## **CABINET MEMBER FOR ENVIRONMENT – 27 JUNE 2019**

### **BURFORD – A40 OXFORD – WITNEY ROAD & B4020 SHILTON ROAD – PROPOSED SIGNALLED CROSSING, TRAFFIC CALMING MEASURES AND EXTENSION OF 30MPH SPEED LIMIT**

**Report by Director of Community Operations**

**Title:**  
 SECTION 278 WORKS  
 TRAFFIC SIGNS & ROAD MARKINGS  
 SHEET 2

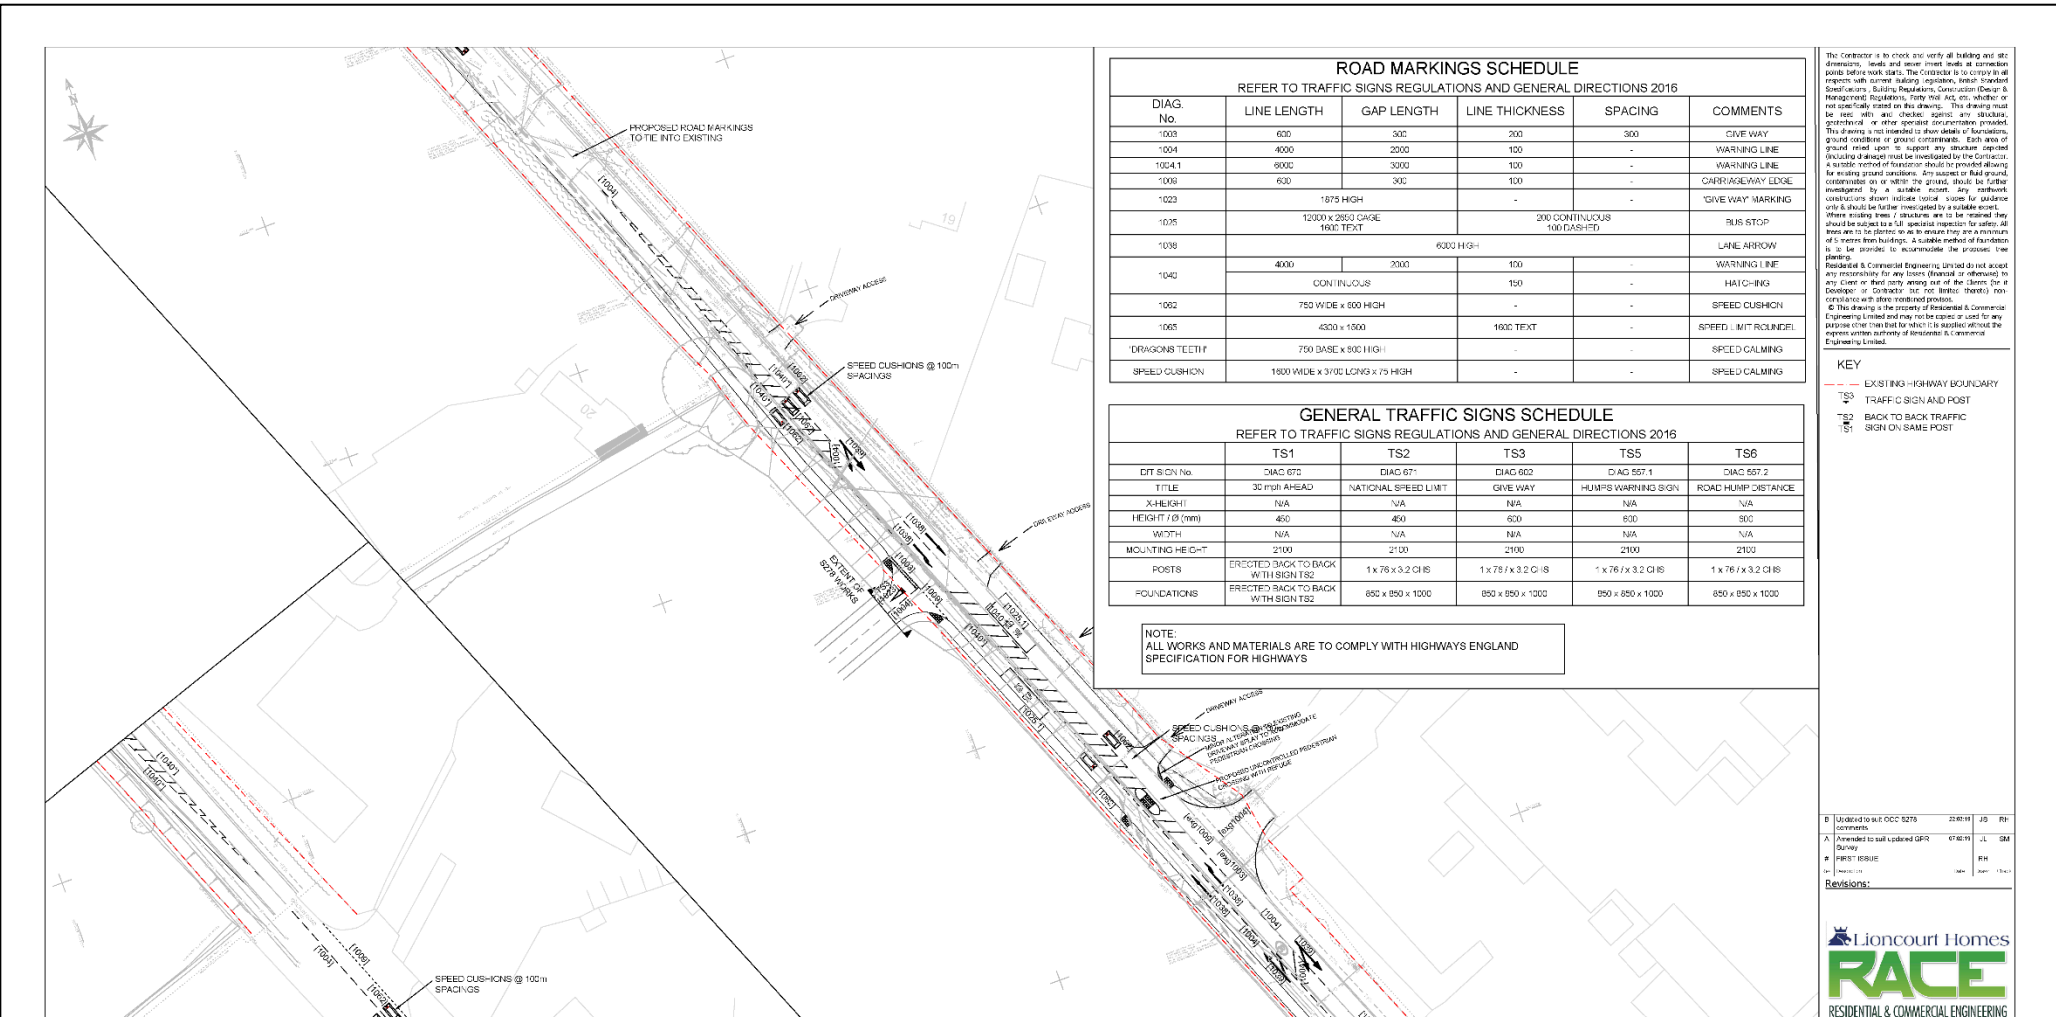
1.1 The draft s278 drawing (Sheet 2) shows a westside footpath terminating part way along Shilton Road with a dropped kerb outside No. 10. Pedestrians, young and old, would have to cross Shilton Road multiple times each day, unaided, to reach their destinations:

1.2 The draft s278 drawing (Sheet 2) proposes that the existing east side footpath be used for part of the walk. This footpath is in poor repair and does not meet standards in several respects.

- The draft s278 drawing (Sheet 2) shows a west side footpath terminating part way along Shilton Road with a dropped kerb outside No. 10. As a result, pedestrians including the young and old, would have to cross Shilton Road unassisted, multiple times to reach their destination:

- The draft s278 drawing (Sheet 2) shows the existing east side footpath being used for part of the way along Shilton Road. This footpath is in poor repair and does not meet standards in several respects.

- Drawing (Sheet 2) shows no intention to upgrade the east side footpath. In any case, a proposal to improve just a short section of this footpath would result in a 'patch work' of repairs, degrading the appearance of Shilton Road. As a result, we would not support such a proposal.

13. In respect of concerns over adjacent footway provision, it is acknowledged that provision of a continuous footway on the west side of the B4020 Shilton Road was agreed at the planning stage and that this should be provided and that while accepting that site constraints will not permit a continuous footway width which meets the Oxfordshire Walking Standards to be delivered, a localised pinch point down to 1m is acceptable and preferable to having to cross the road twice, noting also that the level of pedestrian usage at any one time will be typically fairly low.

PROPOSED 30MPH SPEED LIMIT

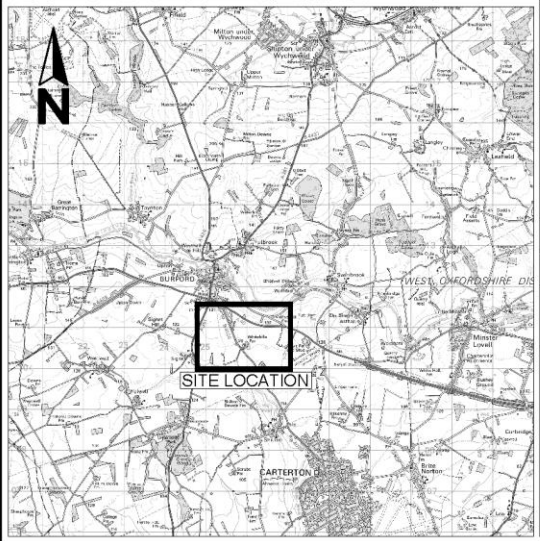
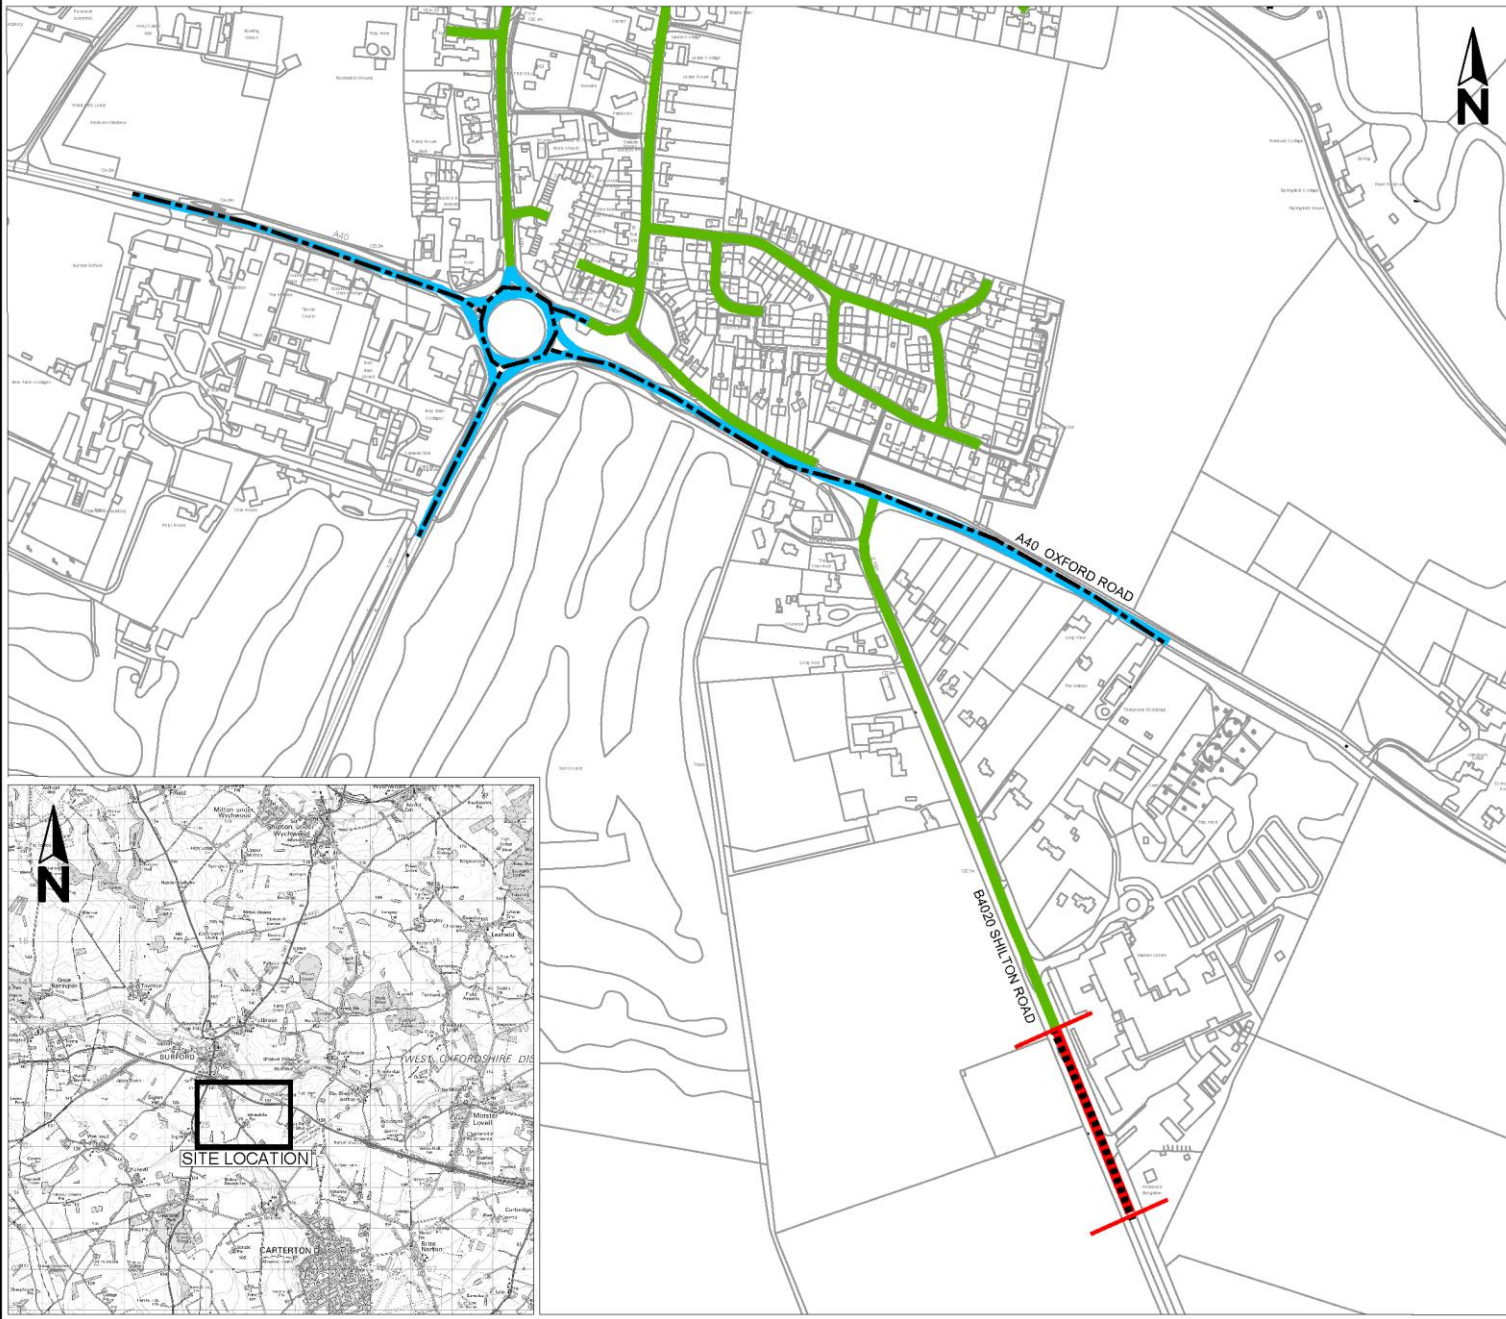
<p>(11) Local Resident, (Burford)</p>	<p><u>Speed Limit</u> - <b>Object</b> - This 30mph speed limit is already too low - there is no need for a 30 limit along this stretch because of minimal pedestrian movements. The alignment of the road doesn't support a 30 limit and it is perfectly safe for vehicles to drive faster than 30mph and extending the limit further will result in even greater limit non-compliance. Vehicles already aggressively tailgate as one enters and leaves the limit at 30mph. Extending it will simply make it worse. Residents will quickly realise how much the limit will be ignored, leading to pressure on councillors to have it enforced.</p> <p><u>Calming</u> - <b>Object</b> - This is a rural area. The bumps, humps and associated street furniture will be ugly and urbanised, spoiling the appearance of a currently attractive road. Residents will suffer noise from vehicles - particularly delivery vehicles to BGC, agricultural vehicles and larger lorries - crashing over the humps. Humps cause drivers' observation to close in, forcing them to concentrate on getting their vehicles over the bumps - rather than observing ahead for pedestrian and cyclist hazards. 'Cushions' like these are extremely dangerous to motorcyclists, particularly in the wet. Humps degrade over time, and OCC has insufficient budget to maintain them (see Brize Norton village where the humps are very badly degraded and damage vehicles). These humps will likewise degrade and become dangerous to two-wheeled road users. Transport Road Laboratory studies show that 'traffic calming measures can cause an increase in harmful tail pipe emissions and CO2, with speed humps tending to have the largest increases.'</p> <p><u>Crossing</u> - <b>Object</b> - The crossing is likely to lead to existing congestion becoming even worse.</p>

(15) Local Resident, (Witney)	<p><u>Speed Limit</u> - <b>Object</b> - not necessary to be so low.</p> <p><u>Calming</u> - <b>Object</b> - never properly maintained, damage to cars.</p> <p><u>Crossing</u> - <b>Neither</b> - probably necessary to allow increased traffic onto main road been necessary at peak times for a long time</p>

<p>(20) Local Resident, (Burford)</p>	<p><u>Speed Limit - Support</u> - It would be much safer if the 30mph limit started on the A40, ideally from both the east &amp; west points where the 40mph limits start, which would reduce the speed that traffic enters the B4020 coming off the A40.</p> <p><u>Calming - Object</u> - They are not environmentally friendly as they increase pollution &amp; noise. They do not stop lorries , buses or motorbikes from speeding. They degrade &amp; become unsightly. They are an archaic attempt to slow traffic &amp; not fit for purpose. They are dangerous &amp; potentially damaging to owners vehicles / caravans /trailers for residents accessing their own driveways where these hideous humps are close to their existing entrances.</p> <p><u>Crossing - Object</u> - The signalised crossing will be very dangerous unless the A40 speed limit is reduced to 30mph &amp; the A40 carriageway is realigned so that there is a full 2 metre wide footpath from the B4020 junction to the crossing. Pedestrian safety &amp; the safety of parents with prams / pushchairs &amp; youngsters will be seriously compromised unless there is a full 2m wide footpath &amp; a reduction in the A40 speed limit.</p> <p>The same safety issues apply to people using mobility scooters, wheelchairs or anyone that is using a walking aid or needing assistance which entails 2 people walking side by side.</p> <p>I would only support a signalised crossing with the 2m footpath &amp; the reduced speed limit.</p>

unnecessary taking account of the character and usage of the road. However, while noting these representations the proposed extension of the speed limit is considered consistent with national guidance taking account also of the proposed development and noting that the above traffic calming measures are also proposed.

EXHIBIT 1

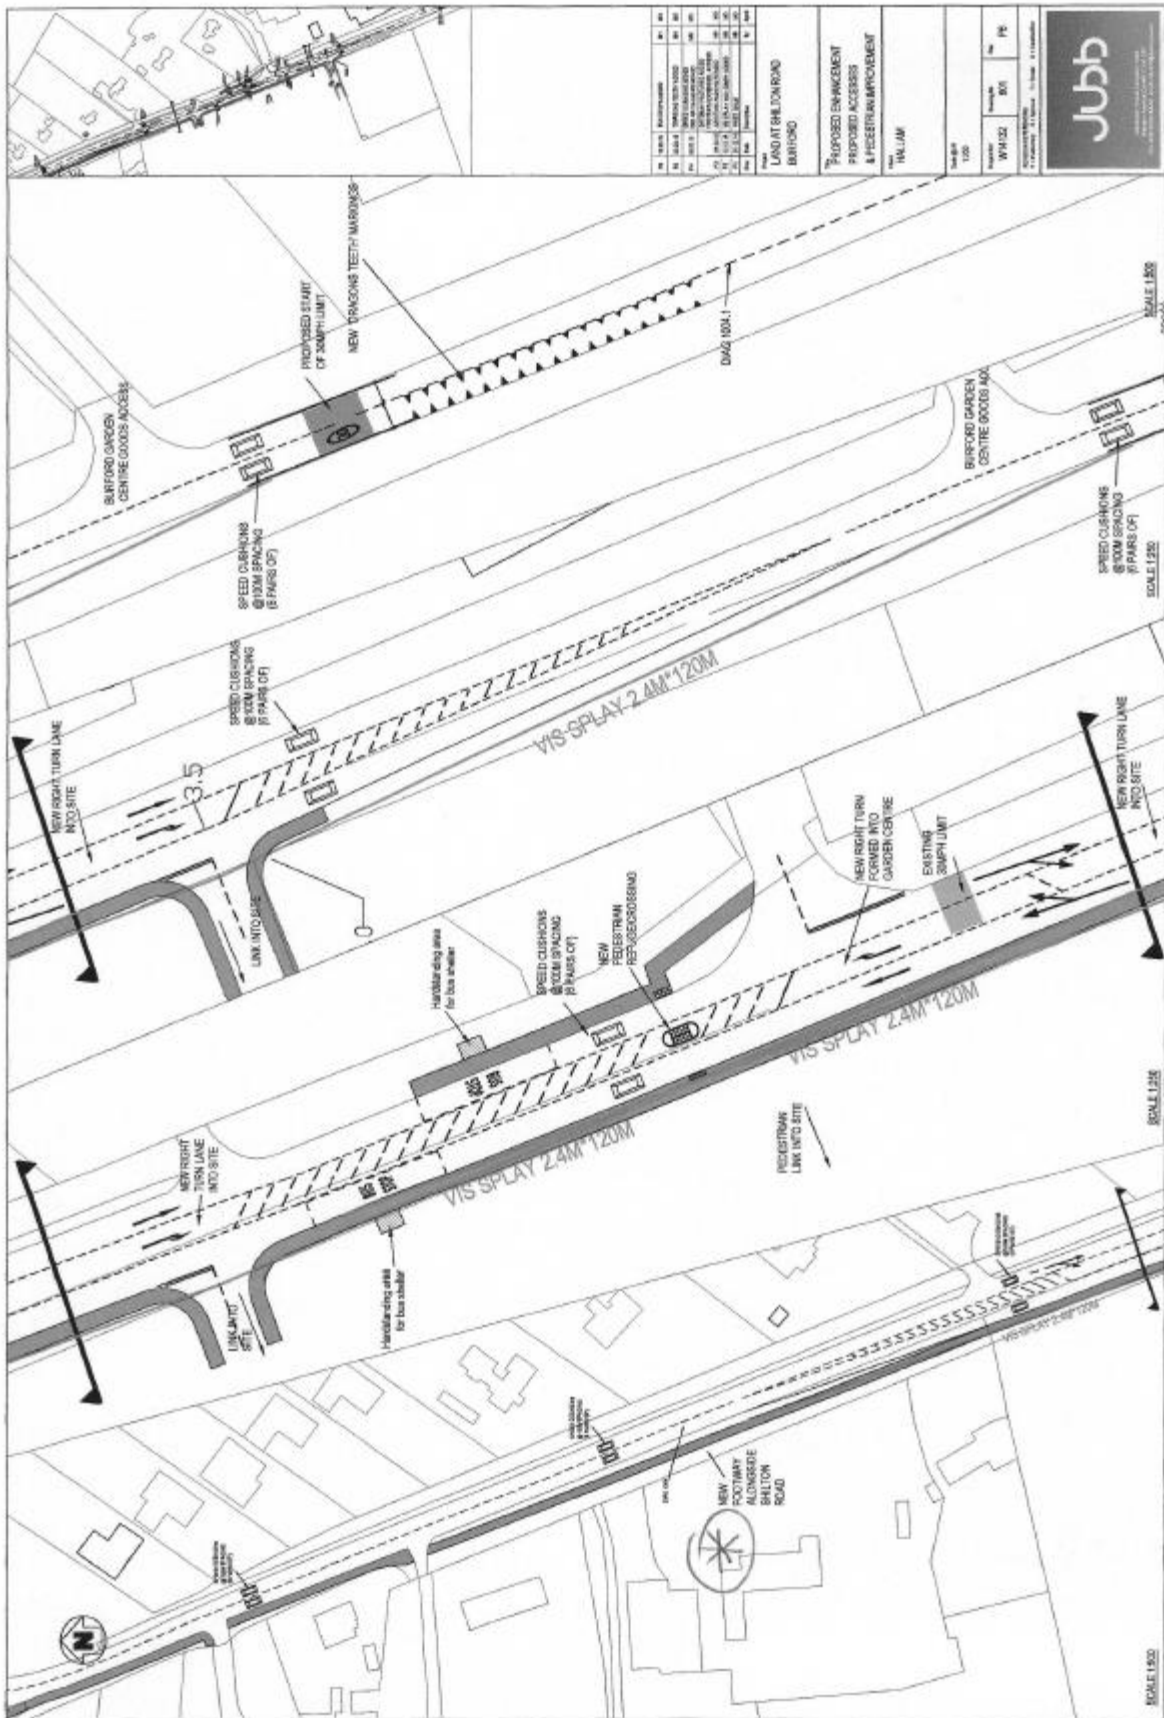
- A new footpath on the west side of Shilton Road between the southern access to the development and the pedestrian crossing on the A40 (Exhibit 1 - Core Document 1.4 drawing reference: W14132/601 rev P2)
